## DEFENSE NUCLEAR FACILITIES SAFETY BOARD

**SUBJECT:** Molten Salt Reactor Experiment: Potential Safety Issues

- 1. Purpose:** This reports documents a review of the Molten Salt Reactor Experiment by Wayne Andrews, Andrew De La Paz, James McConnell, Cindy Miller, Mark Sautman, and William Yeniscavich. The review included two informal visits by the Defense Nuclear Facilities Safety Board staff to Oak Ridge National Laboratory, a video conference on January 4, 1995, and review of relevant documents.

Figure 2: The Molten Salt Reactor Experiment Auxiliary Charcoal Bed

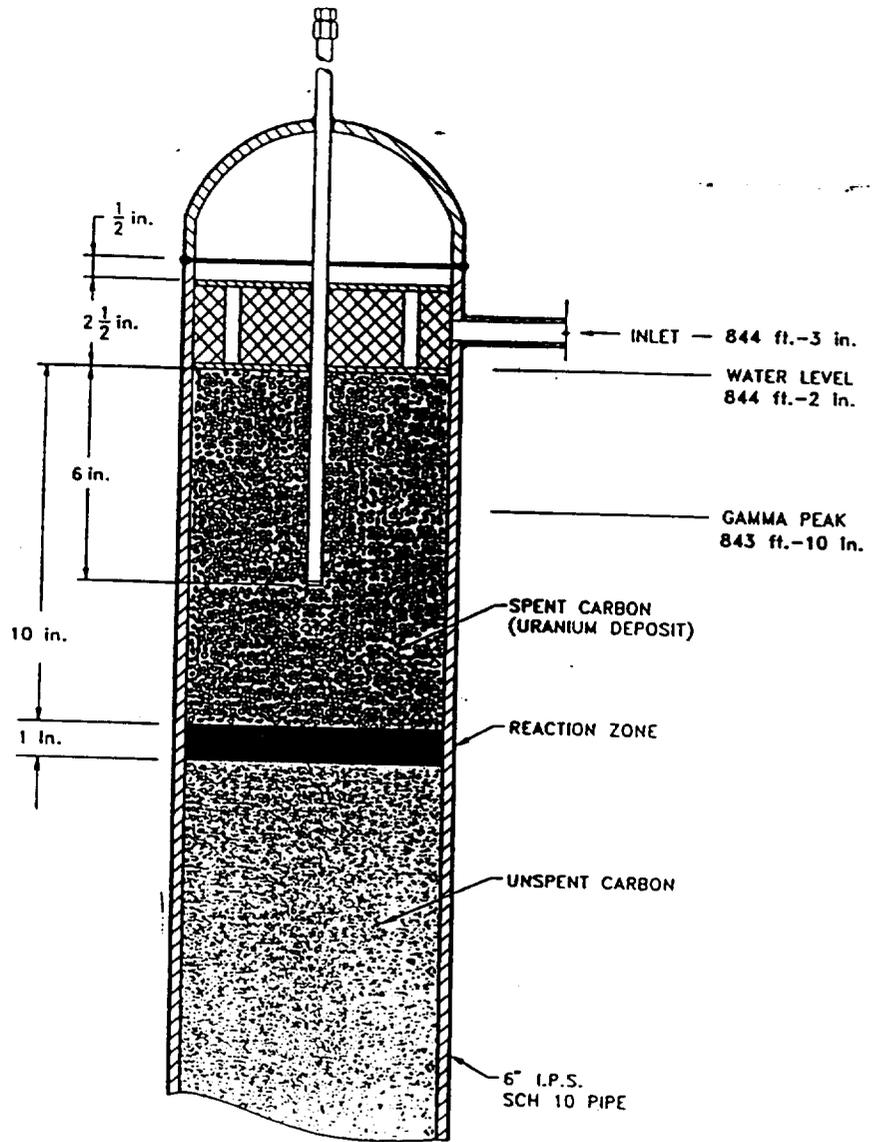
The ACB, part of the off-gas treatment system, consists of two U-tube charcoal traps which are fabricated from six-inch diameter stainless steel pipe. They are approximately 20 ft long per leg. The ACB is located in a 10 ft diameter, 24 ft deep underground concrete pit. The ACB pit was filled with water to cool the charcoal traps and provide shielding during reactor operation. The ACB pit remained full of water until recently. Therefore, the charcoal traps were fully submerged when the uranium was discovered to be located in the ACB.

For the ACB,  $UF_4$  and  $UF_6$  are mixed with the charcoal. The charcoal acts to reduce the uranium atom density. ORNL examined the potential for a criticality for both water inside the ACB and water outside the ACB. ORNL criticality calculations indicate that the only credible criticality scenario for the 2.6 kg of  $^{233}U$  is when water enters the ACB and fills the void spaces in the charcoal bed. ORNL calculations also indicate that water reflection alone, i.e., water completely surrounding the outside of the ACB, is insufficient to cause a criticality event. Thus, the current mass of uranium is theoretically sufficient for a criticality, but sufficient moderation is not present. The recent draining of the ACB pit has significantly reduced the amount of reflection.

Figure 3

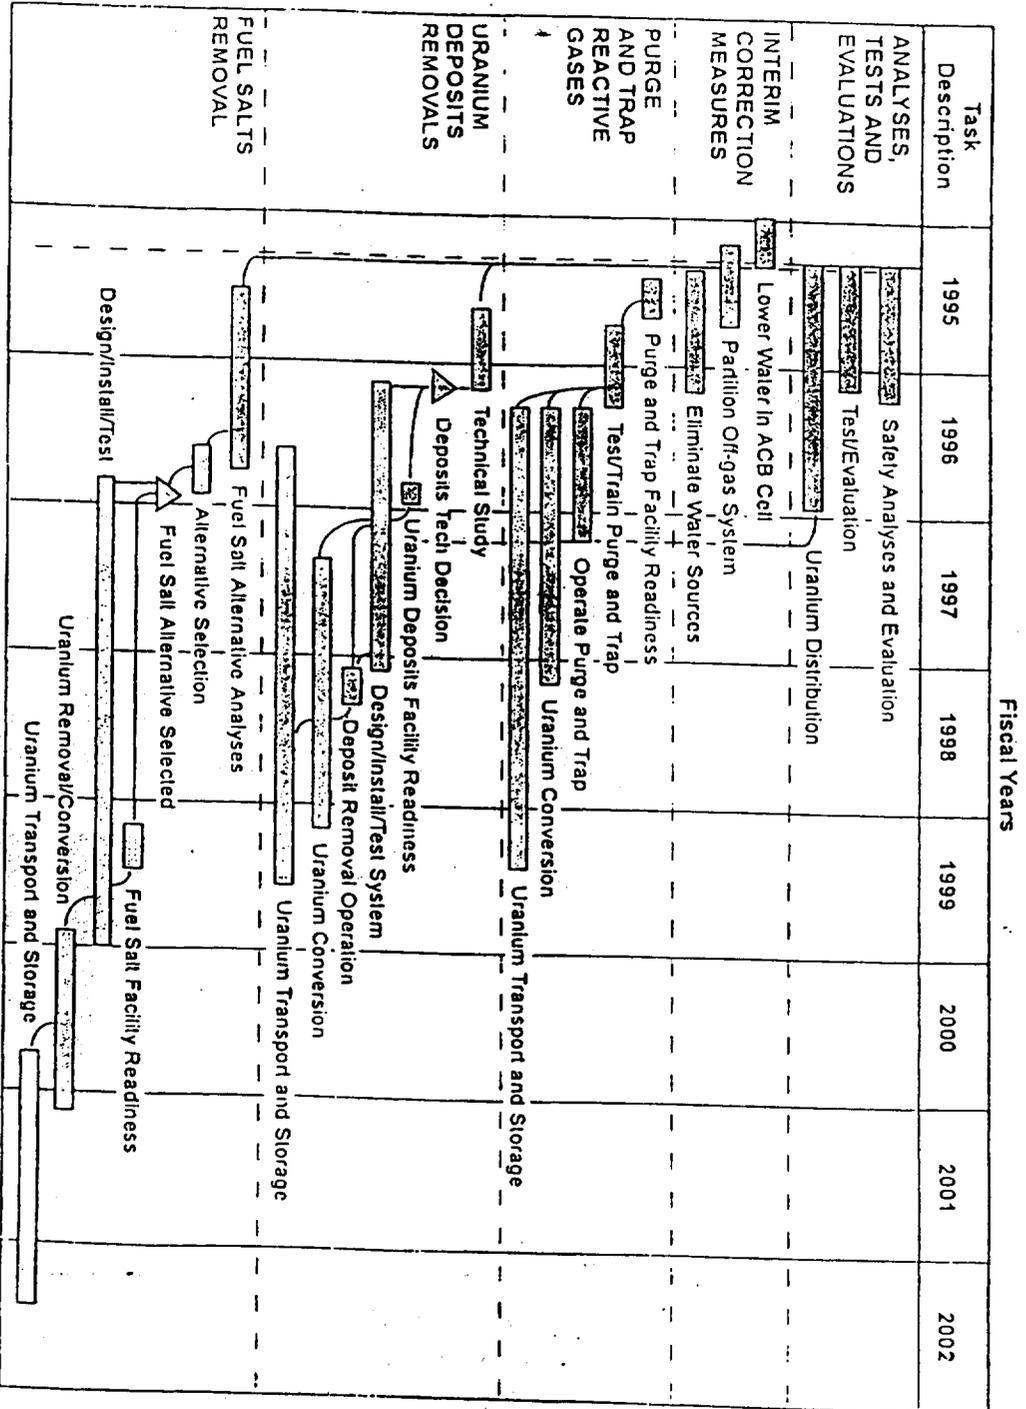
- d. Programmatic Plan: DOE and ORNL have established a plan to address the various issues associated with the MSRE. They have near and long term integrated plans for remediation (Figure 3), along with an associated work breakdown schedule (Figure 4). The key issues are funding for this initiative beyond FY1995 and the lack of urgency with respect to the elimination of water sources.
